Informational FIELD SERVICE BULLETIN

FSB Number: LVCCFSB2005-143 Rev B

Subject: GSM Mid-Tier - Placement of Liquid Detection Labels

Fig. 2.0 - "Good" Placement

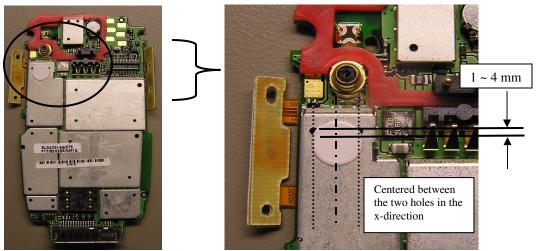
As of April 29th 2005, all factories producing the models (V300, V303, V400, V500, V505, V525, V600E550/V535, V550/V545, V620/V600i, V635) are placing the liquid detection label on the shield in the upper section of the board near the antenna port. See image (Fig. 2.0 – "Good" Placement) below.

Note: The exact position may vary slightly on the shield.

When performing services on any GSM model, listed, that requires the rear housing to be removed allowing access to the water detection label. Remove label that has been placed in SIM card area and place a new label (Part # 5485042F01) on the shield in the indicated location. See images above.
